BRF IM-080-1(308)2--05-78

**BRIDGE REPLACEMENT-STEEL GIRDER**  
**ON 24TH STREET OVER I-80**

## LISTING OF PROJECT REVISIONS

**POTTAWATTAMIE COUNTY**  
**DESIGN NOS. 508 & 708**  
**REVISION SHEET**  
IOWA DEPARTMENT OF TRANSPORTATION - HIGHWAY DIVISION

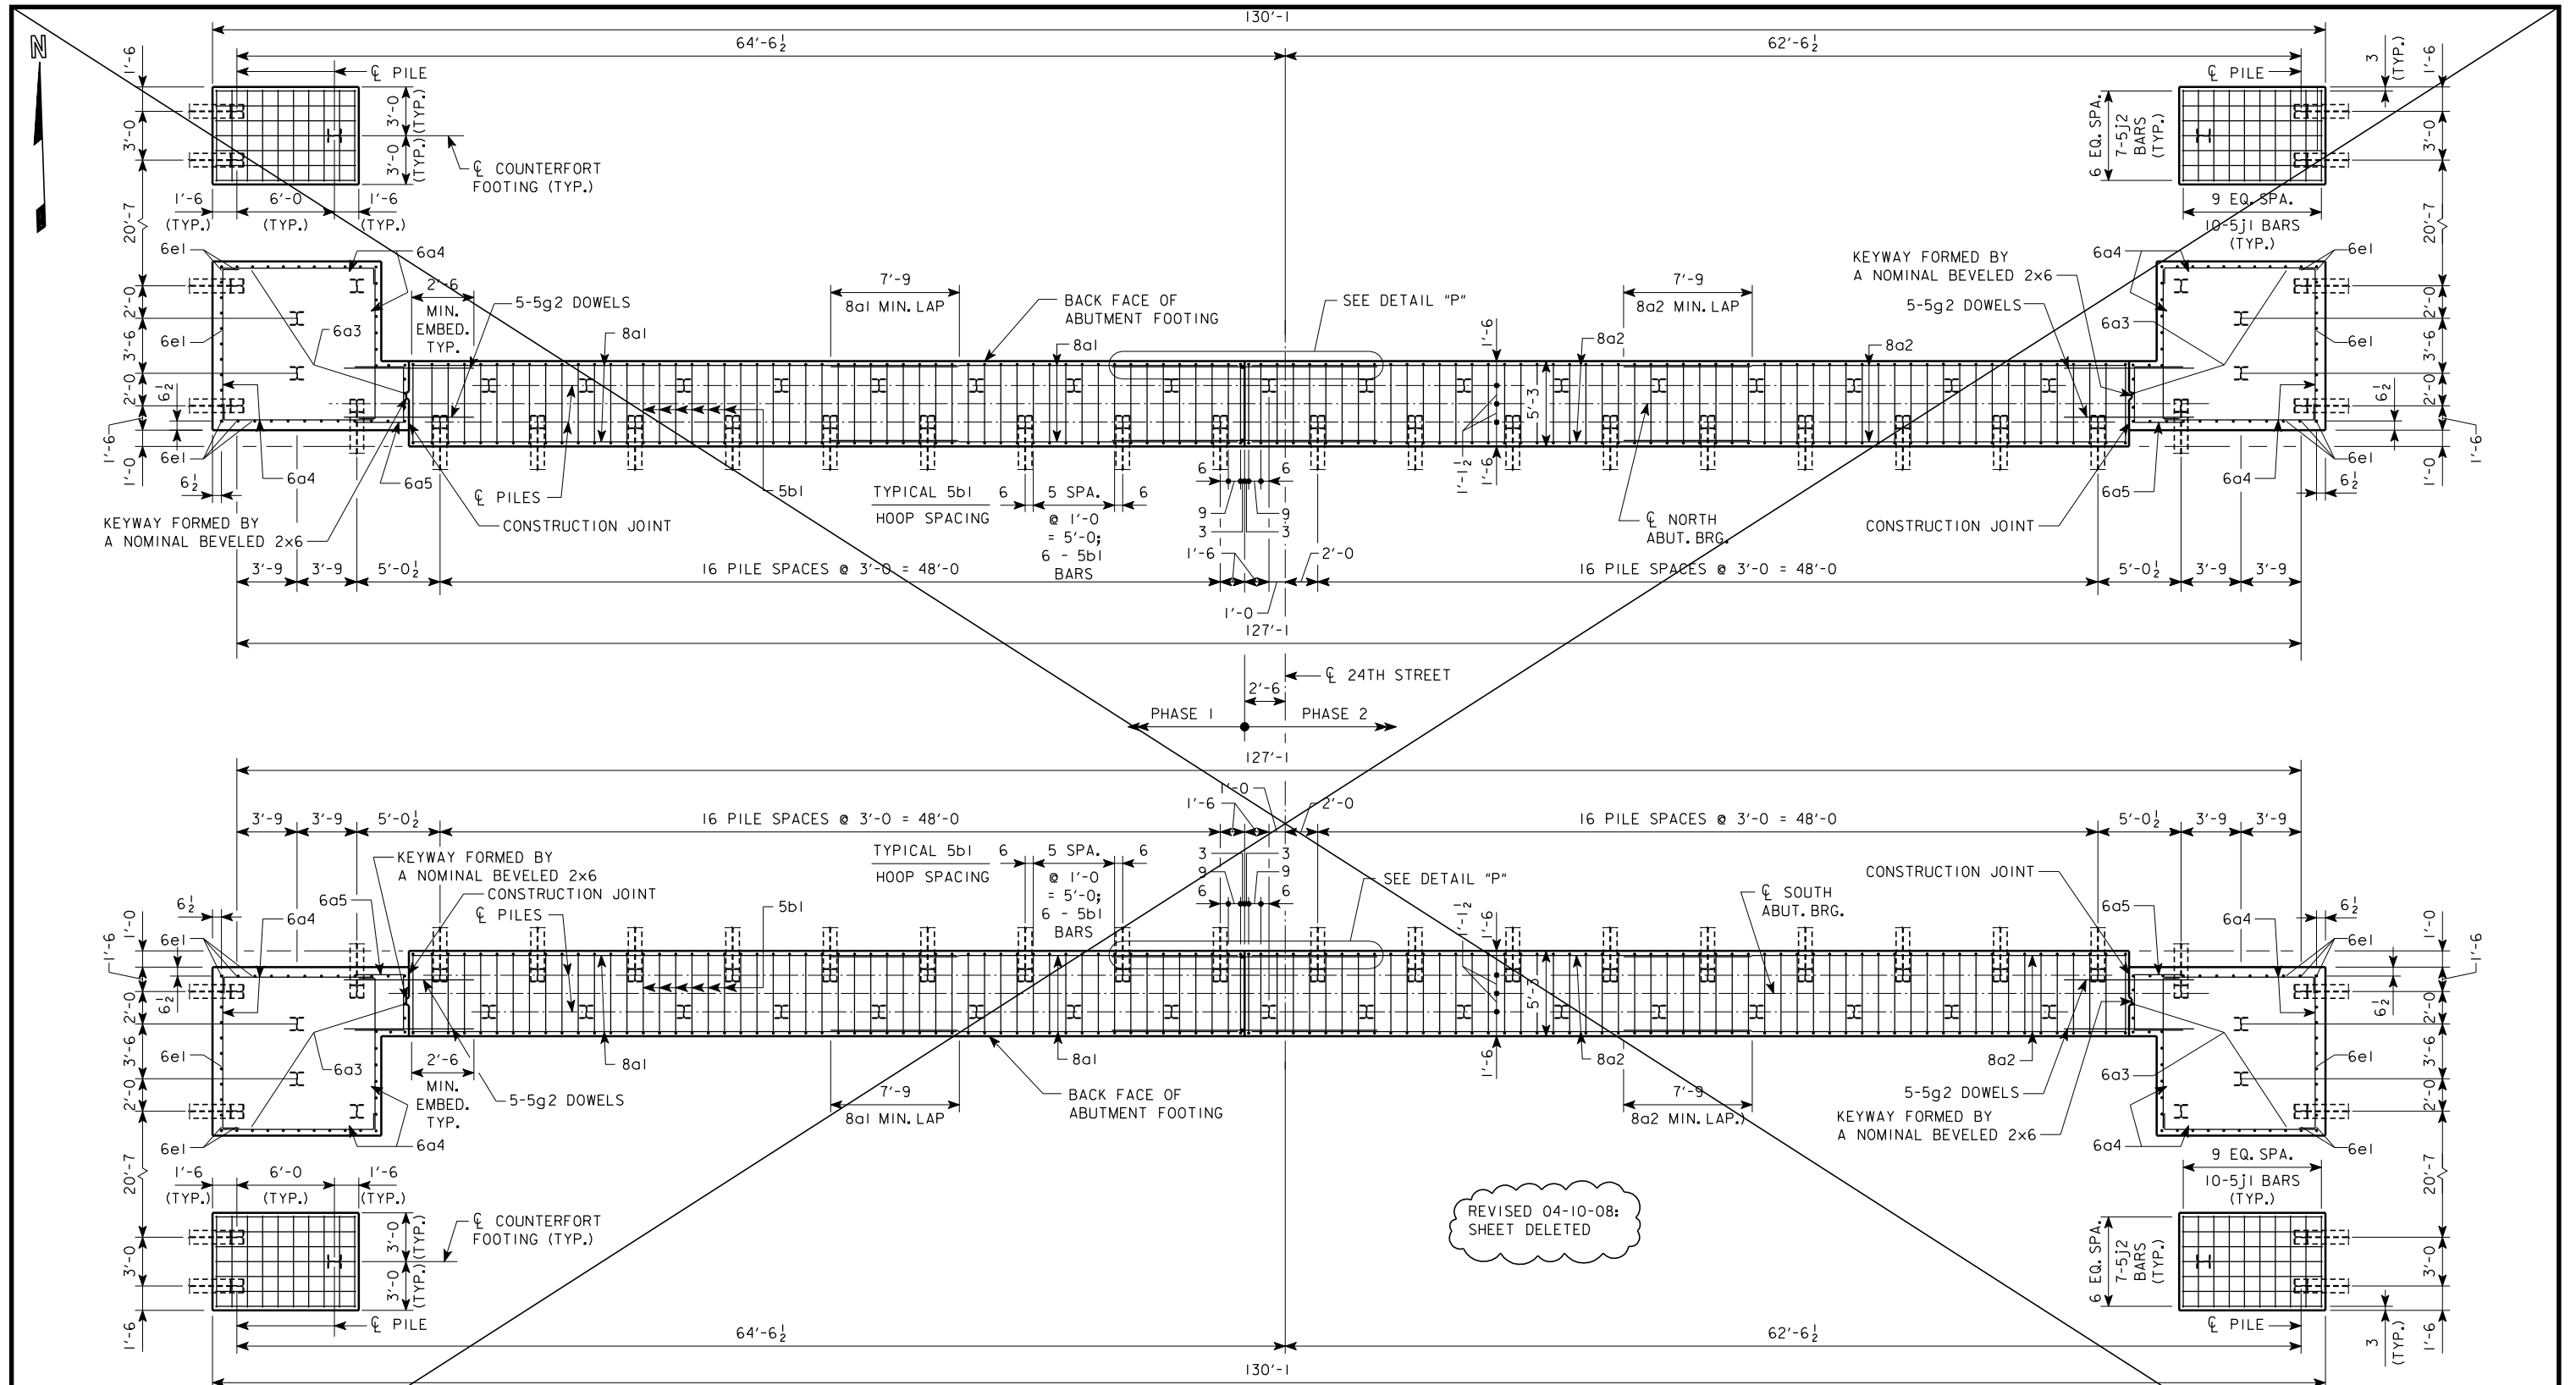
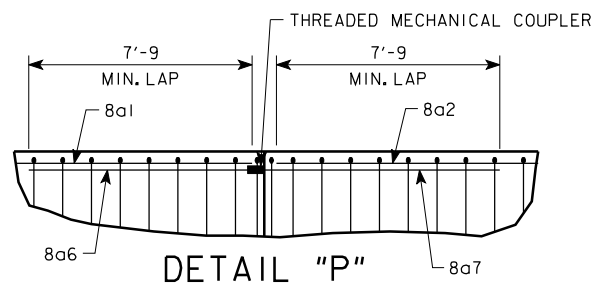
REVISED 04-10-08:  
 SHEET DELETED

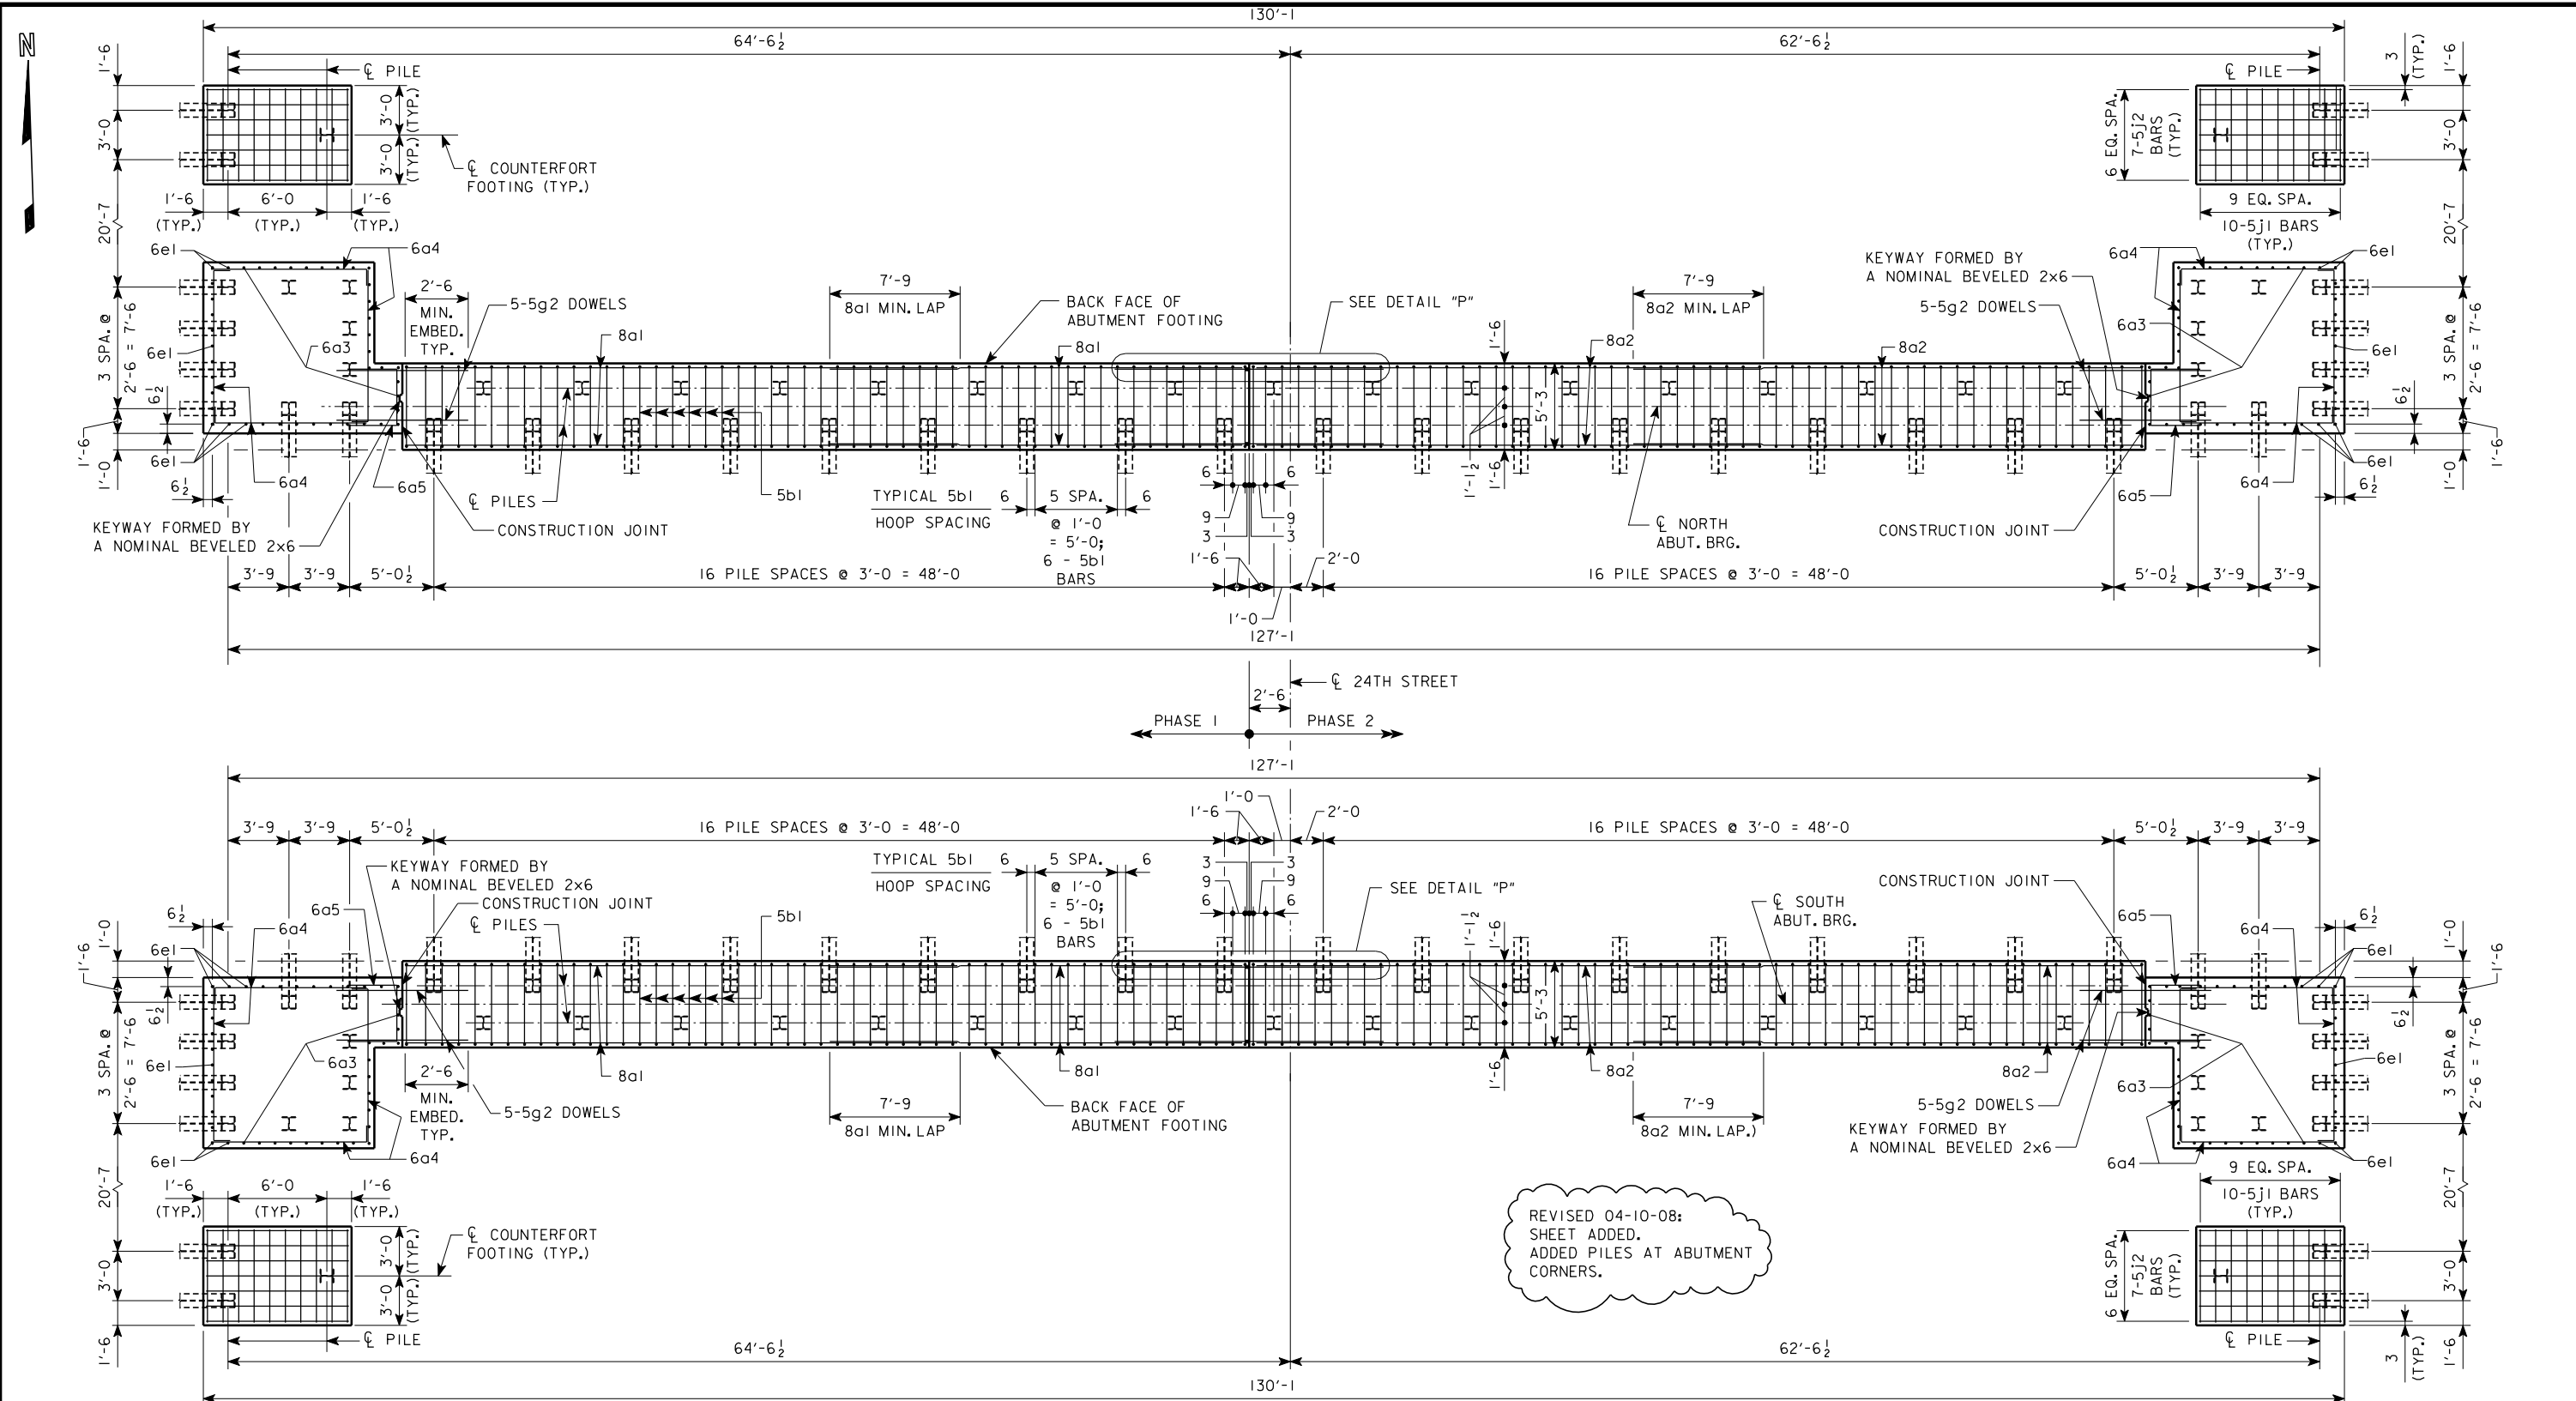
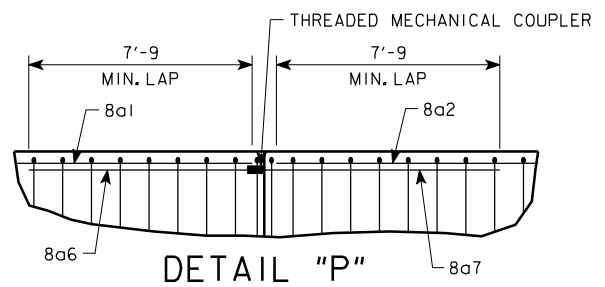
REVISED 04-10-08:  
 SHEET ADDED.  
 ADDED PILES AT ABUTMENT  
 CORNERS.

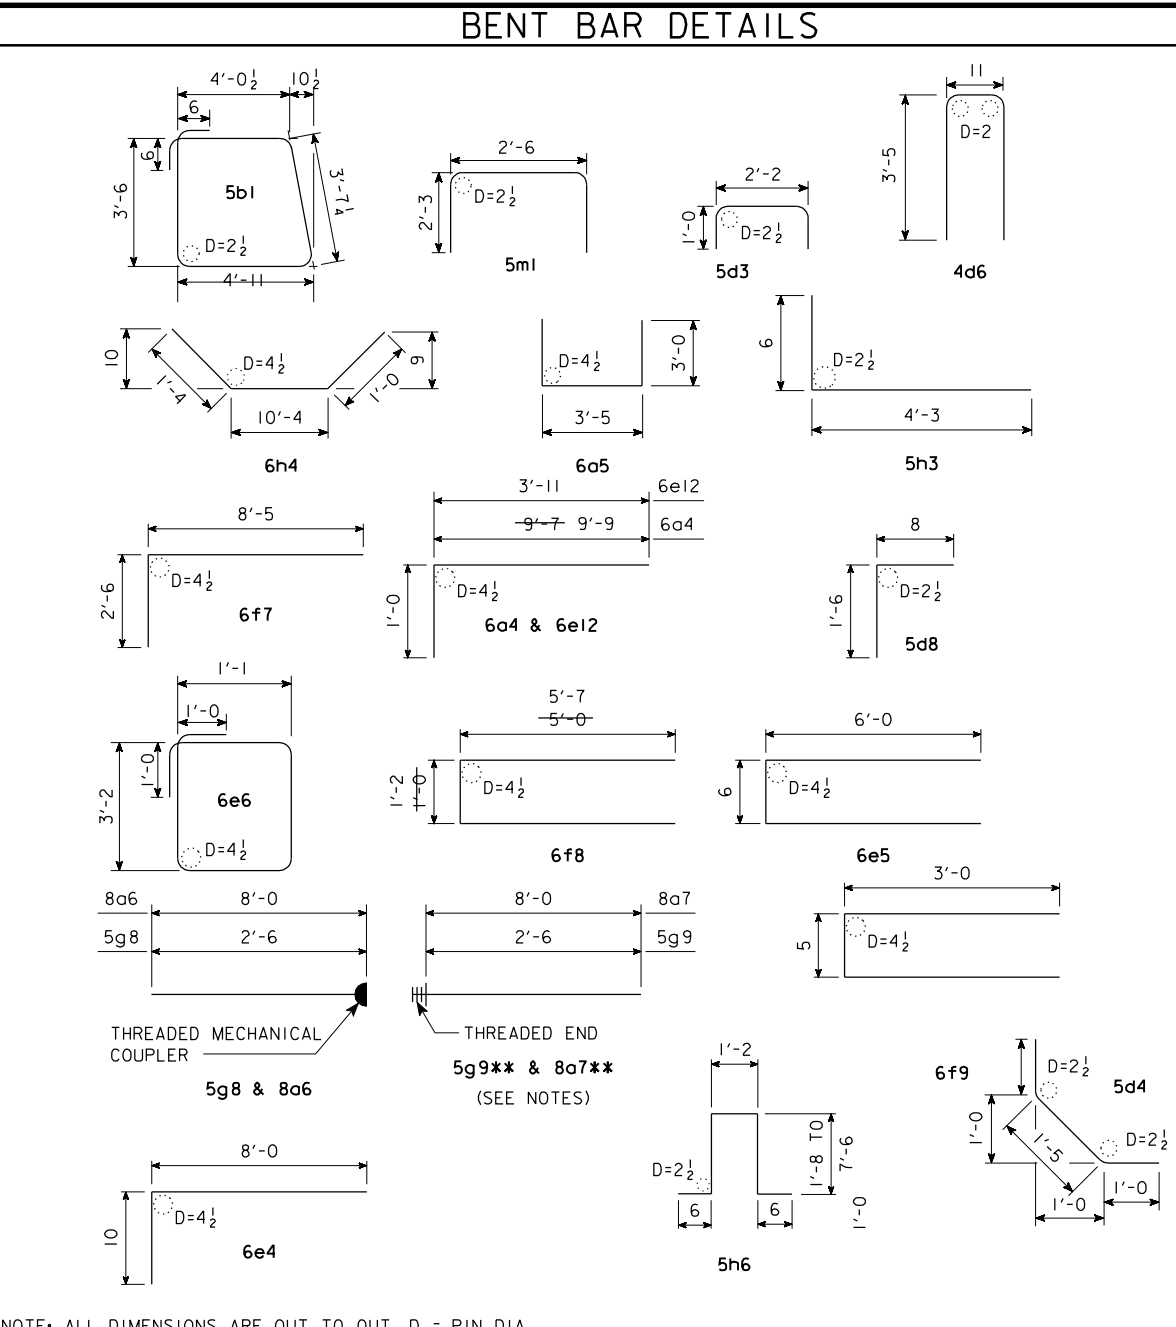
REVISED 04-09-08:  
REPLACED STONE VENEER  
ON OUTSIDE FACE WITH  
FORM LINER.

REVISED 04-10-08:  
ADDED PILES AT  
ABUTMENT CORNERS.

STONE FORM LINER FOR ABUTMENTS SHALL SIMULATE A PATTERN OF SMALL ASHLAR STONES WITH SAWED EDGES ON ALL FOUR SIDES AND A SPLIT OR SNAPPED EXPOSED FACE. STONE SIZES SHALL RANGE FROM 3" x 6" MINIMUM TO 14" x 28" MAXIMUM. MAXIMUM DEPTH OF RELIEF IN THE FORM LINER SHALL BE 1/2" AND JOINT WIDTH SHALL BE 3/4". THE FORM LINER PATTERN AND MANUFACTURER USED FOR ABUTMENTS SHALL MATCH THE FORM LINER USED FOR THE DESIGN 708 TERRACE WALLS ASSOCIATED WITH THIS CONTRACT. ACCEPTABLE PATTERNS AND MANUFACTURERS ARE:
